# Access Compliance Report

## Public Rights-of-Way

### (Curb Ramps)

Intersection ID: 43998	Main Street: GANDER_DR	Cross Street: SUMMERBERRY_CT	Location: SE
ADA ID: CC882984BD26	Ramp Type: Perp	Initial Pass/Fail: Fail	Overall Compliance: No
		Severity Score: 10

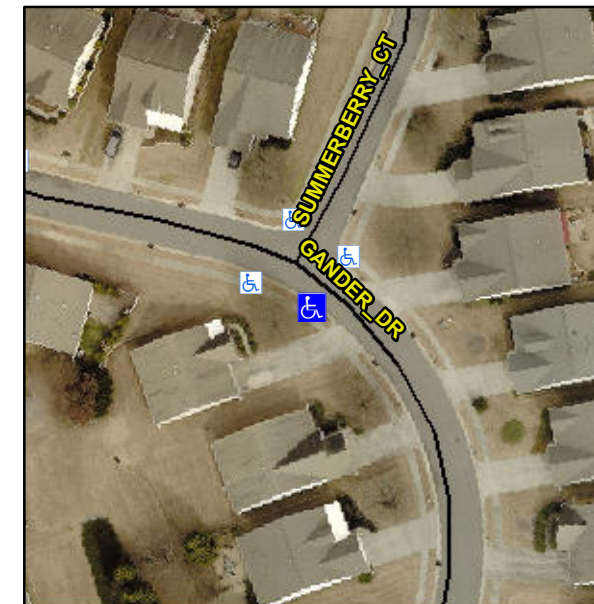
**Not Found, R304.5.1, R304.5.3**

Compliance	Description	Data	Compliance	Description	Data
N/A	Ramp Length (in)	46.0	Yes	Ramp Slope (%)	6.8
No	Ramp Width (in)	46.0	No	Ramp XSlope (%)	4.2
N/A	Flare Type LT	N/A	N/A	Flare Type RT	N/A
N/A	Flare Slope LT (%)	N/A	N/A	Flare Slope RT (%)	N/A
N/A	Flare Traversable LT?	N/A	N/A	Flare Traversable RT?	N/A
N/A	Landing Length (in)	N/A	N/A	DWS Provided?	N/A
N/A	Landing Width (in)	N/A	N/A	DWS Contrast?	N/A
N/A	Landing Slope (%)	N/A	N/A	DWS Length (in)	N/A
N/A	Landing X Slope (%)	N/A	N/A	DWS Full Width?	N/A
N/A	Landing Curb? (Y/N)	N/A	N/A	DWS Offset (in)	N/A
N/A	Shared Landing?	N/A			
N/A	Gutter Ponding?	N/A	N/A	Gutter Slope (%)	N/A
N/A	Gutter Lip Ht (in)	N/A	N/A	Gutter X Slope (%)	N/A
N/A	Painted X Walk1?	No	N/A	Painted X Walk2?	N/A
	X Walk 1 Direction	To NE		X Walk 2 Direction	N/A
N/A	X Walk 1 Width (in)	N/A	N/A	X Walk 2 Width (in)	N/A
	X Walk 1 Slope (%)	4.7		X Walk 2 Slope (%)	N/A
	X Walk 1 X Slope (%)	2.2		X Walk 2 X Slope (%)	N/A

**Remove & Replace Entire Ramp.**
